DRAFT

**Specific Site Assessment for
Coal Combustion Waste
Impoundments at Duke Energy
Carolinas Lee Steam Station**

Williamston, South Carolina

LEE STEAM STATION - ASH BASIN
Primary Dike @ STA 6+00

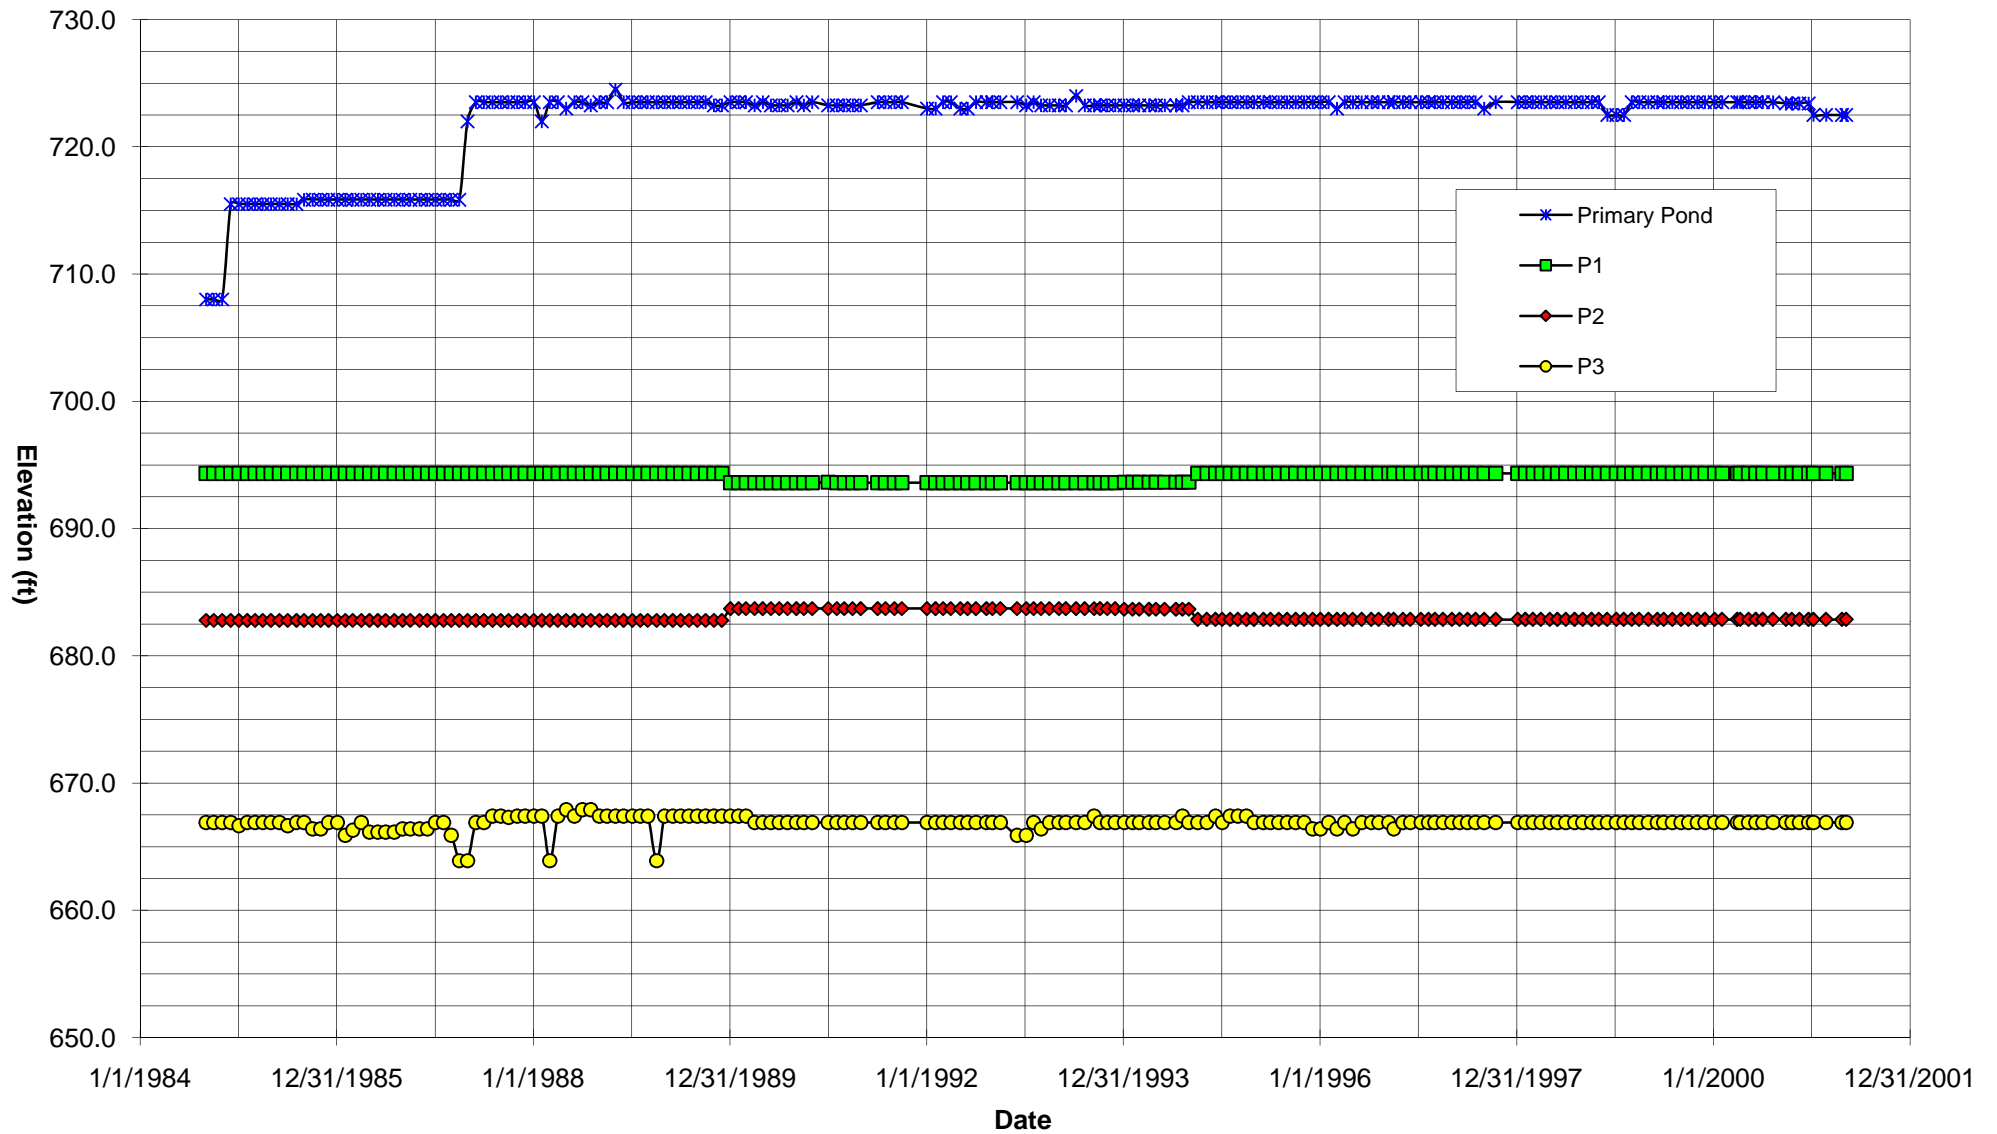
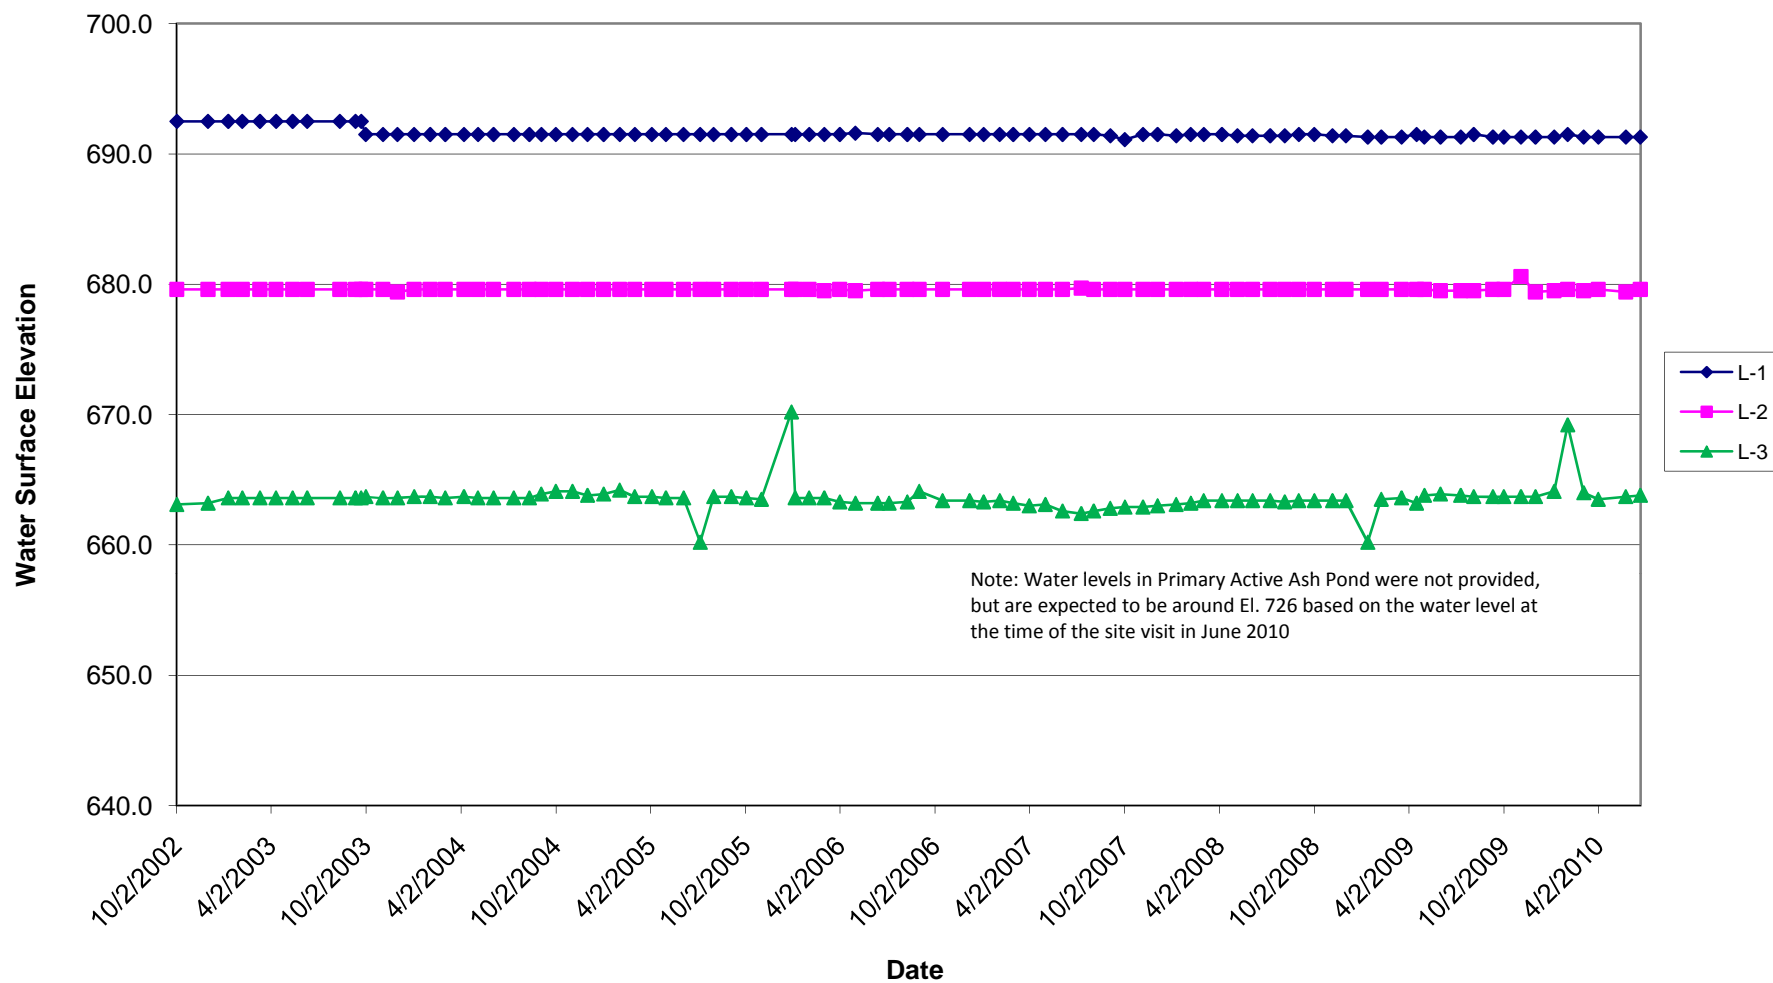
The water levels in piezometers L-1, L-2 and L-3, near the left abutment of the Primary Active Ash Pond dam, have remained relatively steady with time. The water level in piezometer L-3, at the dam toe, rose 6 to 7 feet in December 2005 and February 2010, but returned back to consistent levels in subsequent readings. The cause for these erratic readings is unknown.

LEE STEAM STATION - ASH BASIN
Primary Dike @ STA 13+10

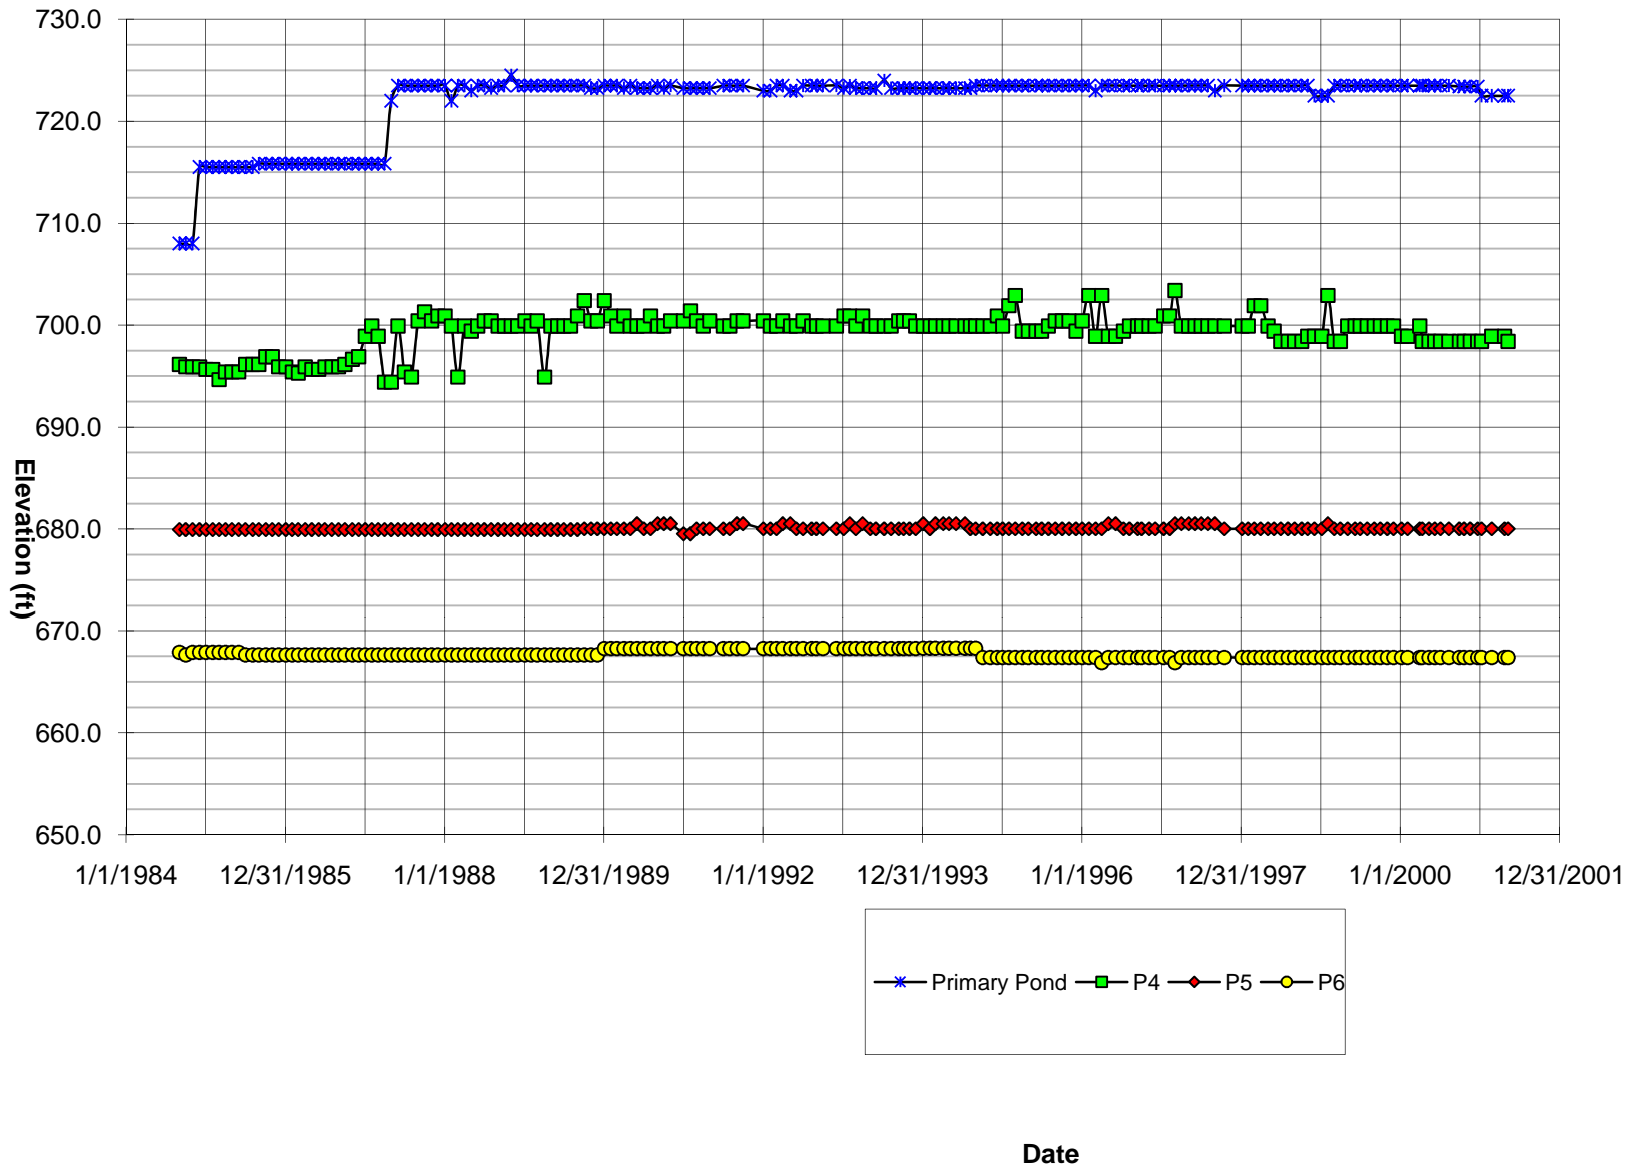
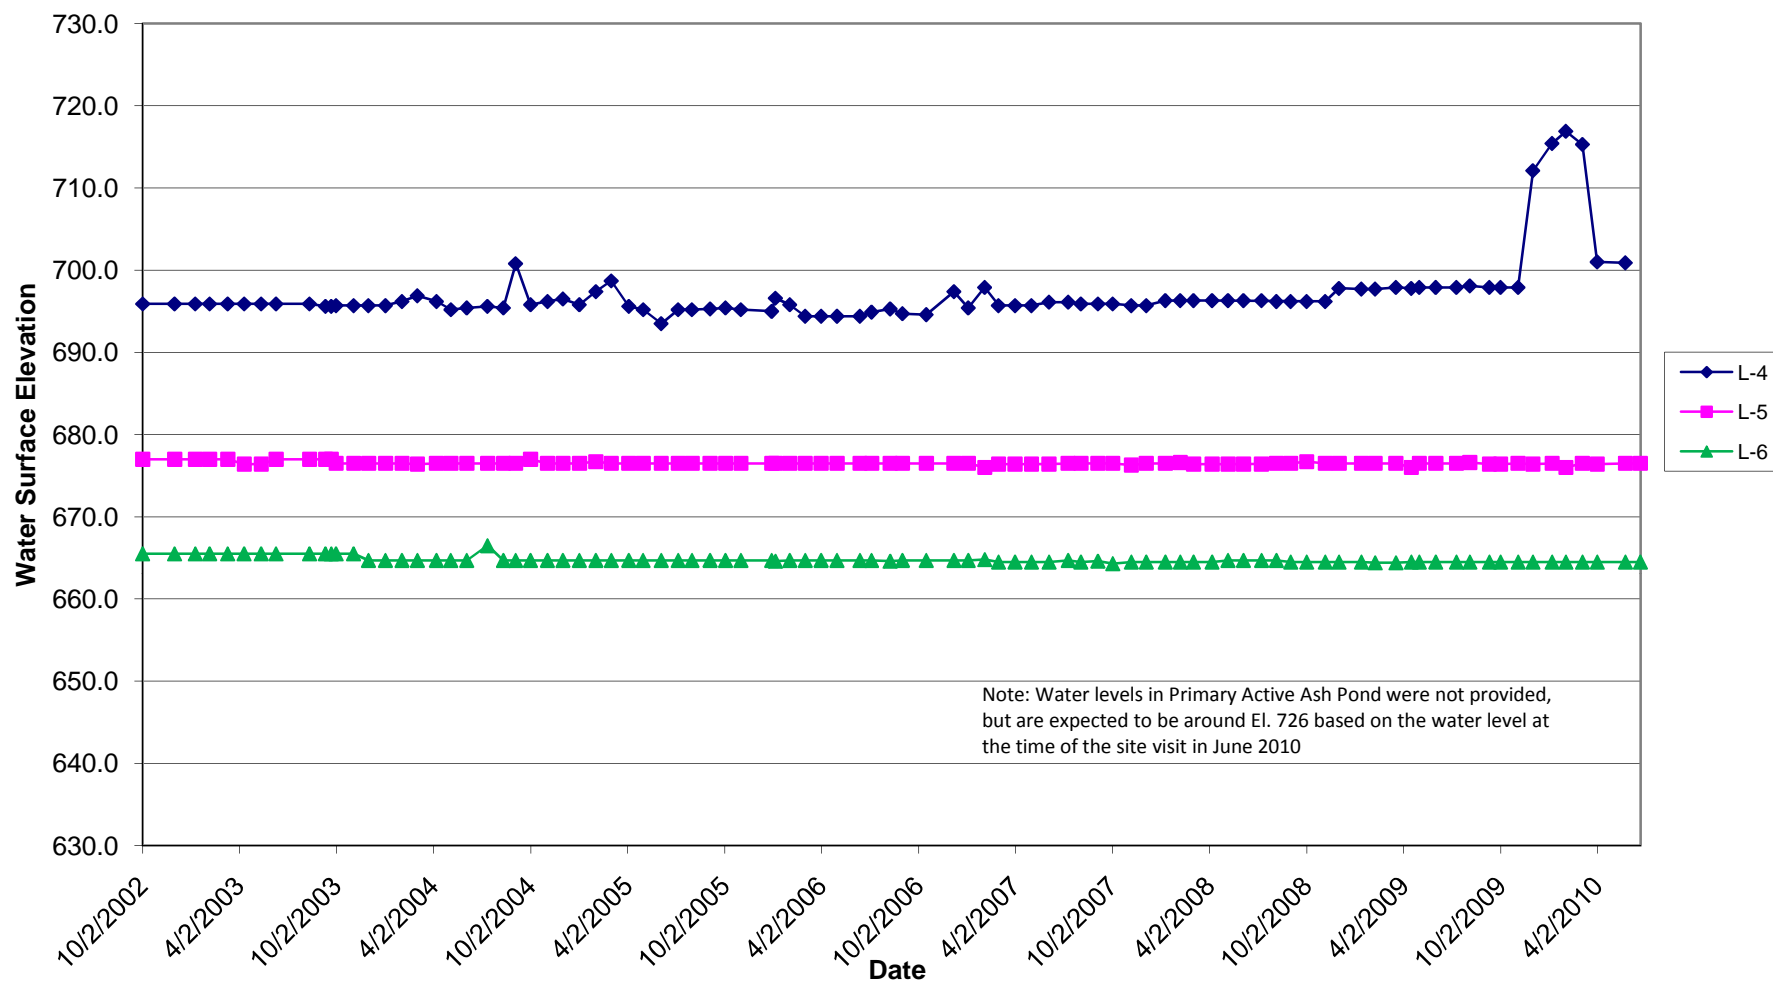
The water levels in piezometers L-5 and L-6, the lower two piezometers near the right abutment of the Primary Active Ash Pond dam, have remained relatively steady with time. The water level in piezometer L-4, near the dam crest, fluctuated regularly within several feet until around 2007. From 2007 until August 2009, the water level in L-4 rose steadily, and

between December 2009 and April 2010 it rose about 17 feet. In April 2010 the water fell back to within several feet of its previous levels. The cause for the sudden rise in water level in piezometer L-4 is unknown.
